Peer Review Report

London Avenue Canal I-wall Load Test

EMC Consultants

July 2007

Figure B-9 – Plan of Instrumentation

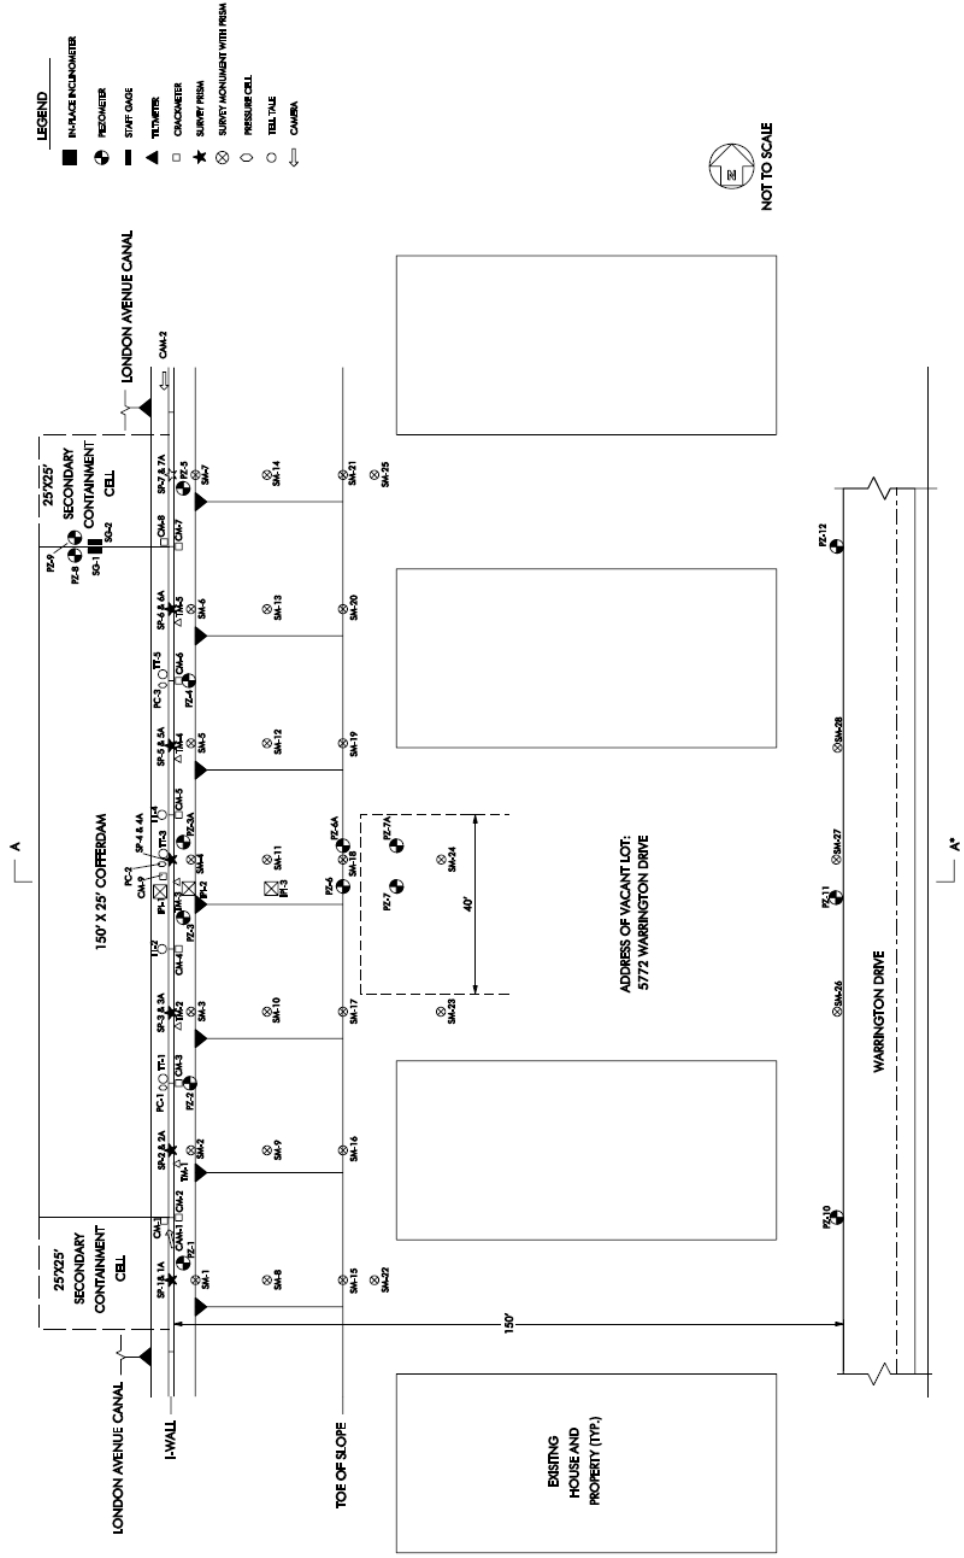
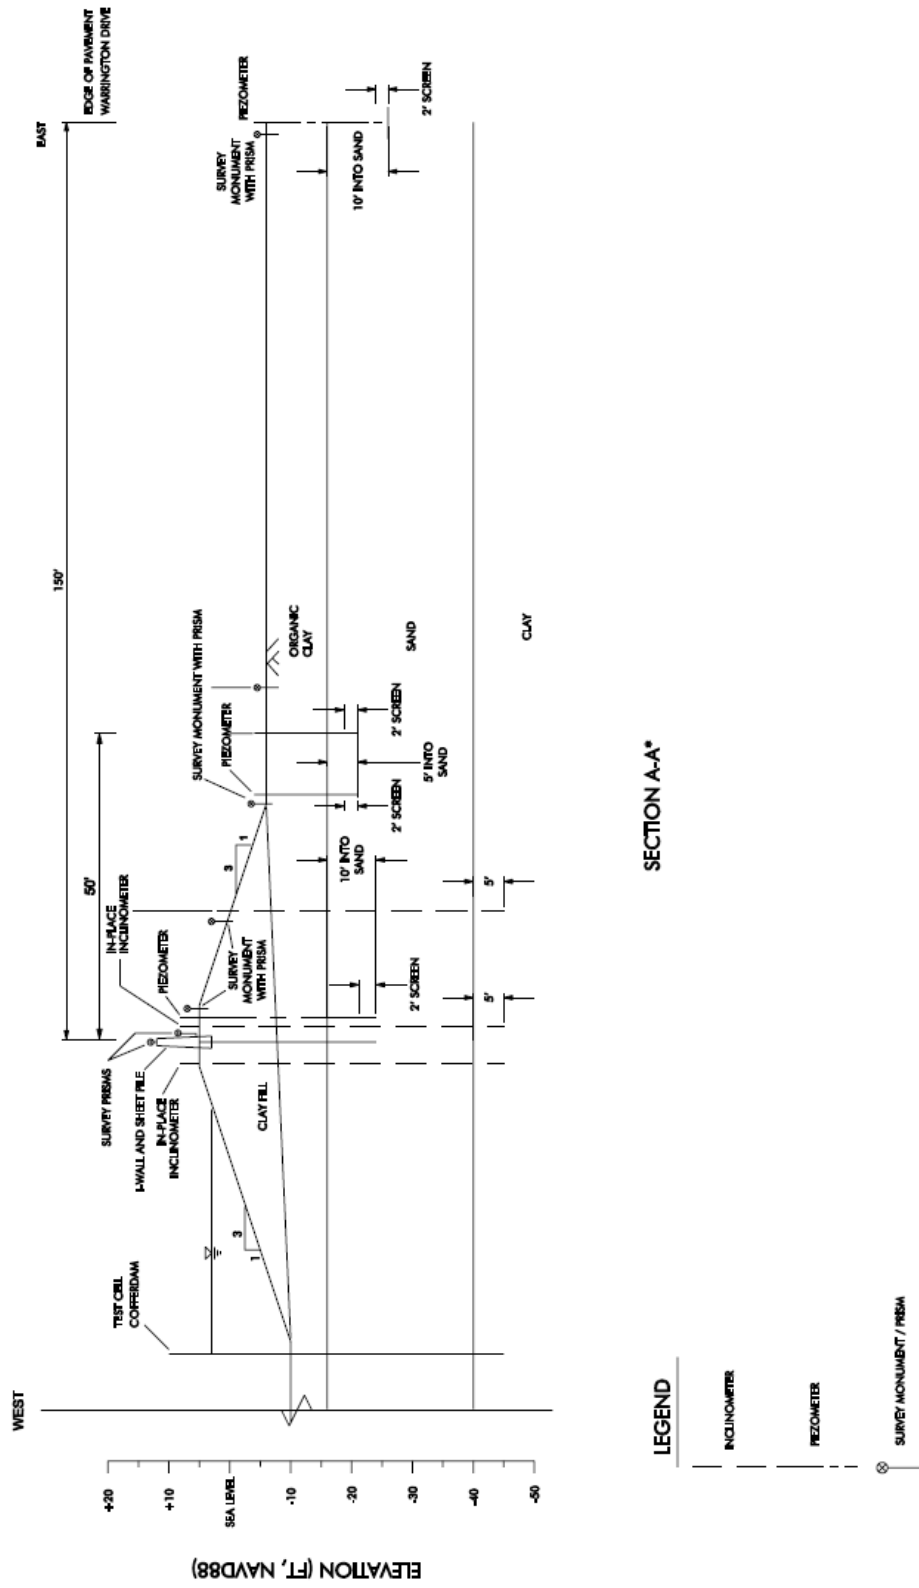
An extensive instrumentation network is proposed by USACE. The instrumentation plan appears to be appropriate for monitoring the planned load test. With the additional consideration of the under-seepage mode of failure as noted by Vroman, Brandon and Schwanz⁽⁴⁾, additional concerns are raised about pore pressures and their impact on stability during the load test. This concern about the potential pore pressure induced instability must be addressed in the monitoring program. Pore pressures in the sand must be estimated before the test at each monitoring well location such that threshold levels are assessed at every stage of loading. This failure mechanism is the major risk

associated with the second stage of the load test program and must be very carefully evaluated before proceeding with the test. The authors believe that additional piezometers should be considered for assessing under-seepage conditions. Furthermore, the authors believe that the inclinometers, the crackmeter, and the total stress cell included in the current instrumentation plan will provide less useful information than piezometers.

Additional piezometers should be specified. Piezometers should be placed on the slope of the levee embankment from the I-wall to the toe of the levee. These piezometers will be critical to the monitoring of the advancement of the increased pore pressures during the each load test increment. Piezometers can be used to assess the flow regime in the critical direction perpendicular to the levee, as well as to assess the potential for three-dimensional effects induced by the proposed cofferdam. Suggested piezometer locations should be developed by USACE using input from Vroman, Brandon and Schwanz prior to initiating the load test. The authors would be pleased to review and comment on the proposed instrument locations when they are selected.

Figure B-16 – Comparison of Water Pressures at Stratum B/D Interface for Canal Sand Bottom with/without a Gap and Test Section with/without a Gap

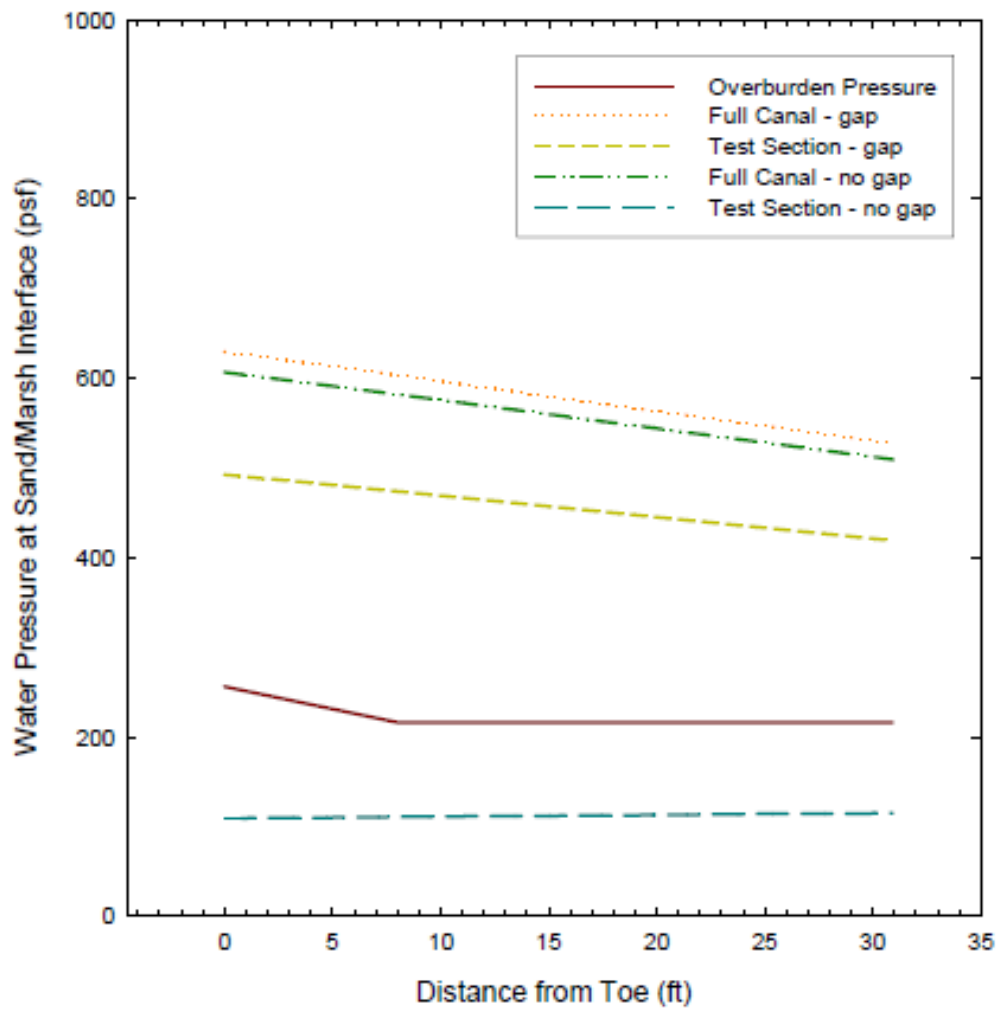
Brandon ⁽⁷⁾ evaluated exit gradients near the protected side toe of the levee and estimated the stability of the test section with the assumption that sand was in the bottom of the canal and the water level in the canal was at El +6 NAVD. Brandon's study found that the I-wall-levee would likely fail due to high exit gradients. In a separate analysis he also estimated uplift pressures on the base of the marsh clay of Stratum B due to water in the cofferdam at El +6 NAVD under two cases ⁽⁸⁾. In this analysis, the initially proposed cofferdam location on the in-canal slope of the levee was designated "Test Section". An expanded cofferdam, which included the provision that canal water was in direct contact with the sand, was designated "Full Canal". Figure B-16 ⁽⁸⁾ of Appendix B summarizes Brandon's analysis and illustrates the impact of the two cofferdam locations. Both analysis cases consider two alternatives. One alternative assumes that no gap exists between the I-wall and the levee embankment clay soils. The second assumes that a gap forms between the I-wall and the levee embankment clay soils during the load test, providing full canal hydrostatic pressure to the surface of the sands through the gap. The impact on this gap on water pressures in the sands at the base of the marsh clays was discussed above. For the Test Section case with no gap formation, the uplift pressures

are less than the overburden pressures for all locations from the toe of levee on the protected side to a distance 30 feet beyond the toe. For the Full Canal case with no gap, the uplift pressures are almost three times the overburden pressures. This illustrates the impact of canal water elevation, particularly when the canal is in direct contact with the surface of the sands. When a gap was introduced into the analysis of the Test Section case, the uplift pressures were increased to about 2.5 times the overburden pressures for the Test Section case. When the gap was added to the Full Canal case, the uplift pressures were only slightly higher than for the Full Canal case with no gap.

The Schwanz analysis results indicate the most critical potential I-wall/levee failure mode occurs when the canal water has direct contact with sand in the bottom of the canal. The authors recommend that both the gap failure mode and the critical under-seepage failure mode be evaluated in the load test. As described in the following section, USACE has suggested modifications to the load test program to incorporate these recommendations.

Figure B-17 – Cross Section for Analysis of Injection Wells with Fully Penetrating Sheetting

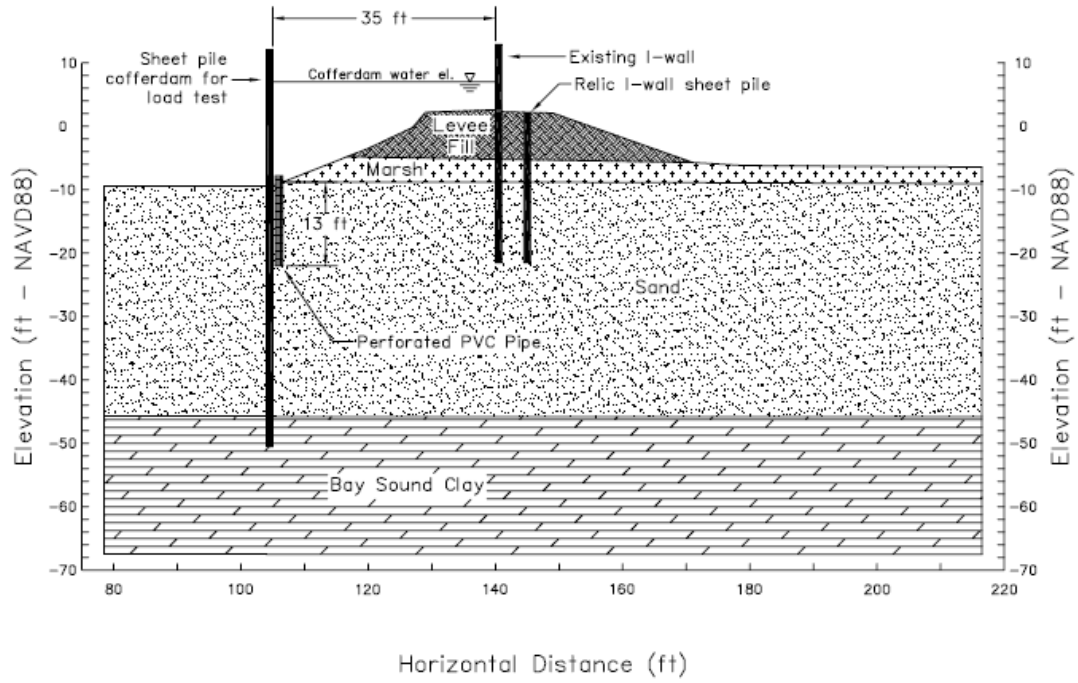
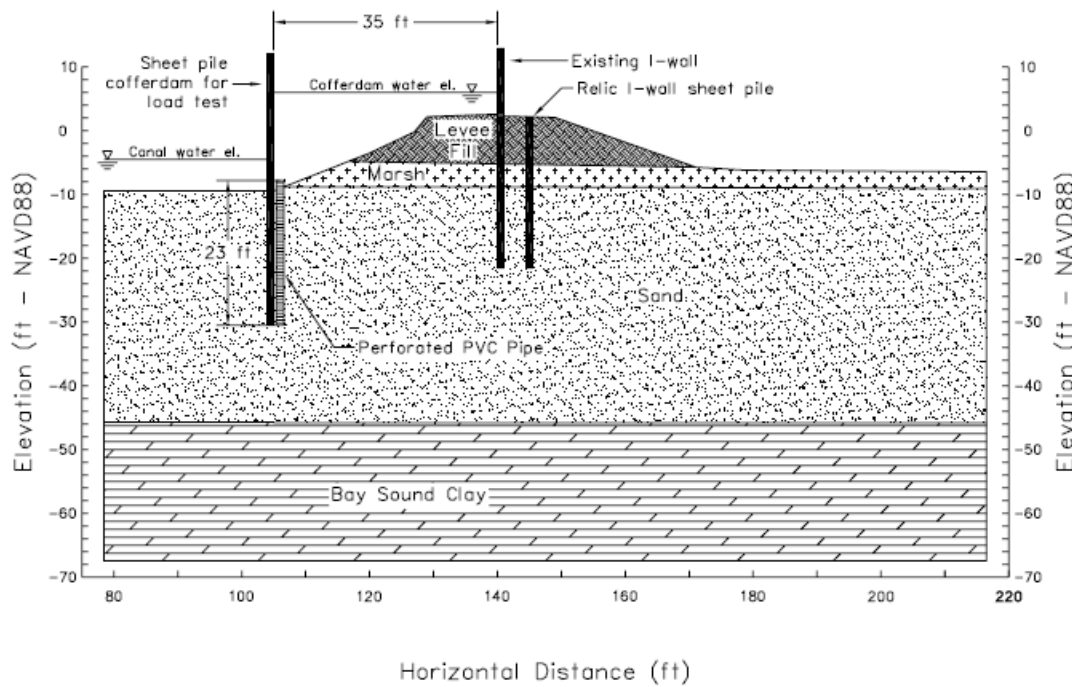
The calculations by Vroman and Brandon ⁽¹¹⁾ indicated that the required depth of penetration of the injection wells is significantly impacted by the penetration of the sheetpiling. The cross sections for the fully and partially penetrating cases analyzed are included in Figures B-17 and B-18 ⁽¹¹⁾, respectively, of Appendix B. Figures B-19 through B-21 of Appendix B illustrate the required depth of injection well penetration for the case of fully penetrating sheetpiling. Fully penetrating sheetpiling will extend into the bay/sound/estuarine clay. The elevation of the tip of the injection well for this case is El -22 NAVD or 13 feet into the sand. When partially penetrating sheeting was considered using sheetpile tips at El -31.5 NAVD, the required tip of injection wells was found to be at El -31.5, the tip elevation of the sheetpiling as noted above. Figures B-22 and B-23 illustrate the comparison of injection well pore pressure at the I-wall sheeting tip and the pore pressures at the protected side toe of the levee embankment at the interface between the marsh clays and the sands. The basis of comparison is the calculated pore water pressures considering the Full Canal loading scenario. These

figures indicate that the partially penetrating sheetpiling can be used, but that the use of partially penetrating sheetpiles adds an additional unknown to the analysis of the load test results. The analysis by Vroman and Brandon assumes subsurface conditions that may not be the same as found below the test section. The use of fully penetrating sheeting will eliminate this unknown and help assure that the potential worst-case analysis conditions are modeled.

The partially penetrating sheeting requires deeper injection wells and greater injection water volumes to simulate the condition of fully penetrating sheeting because some of the water from the cofferdam will flow beneath the sheetpiles and towards the canal instead of towards the protected side. To reduce this unknown in the analysis of the test results, the authors recommend that fully penetrating sheeting be used to construct the cofferdam. The authors understand that USACE has modified the load test program to incorporate these recommendations and will incorporate the Vroman and Brandon⁽¹¹⁾ calculation results regarding the location and depth of the sheetpiles and the depth of the injection wells.
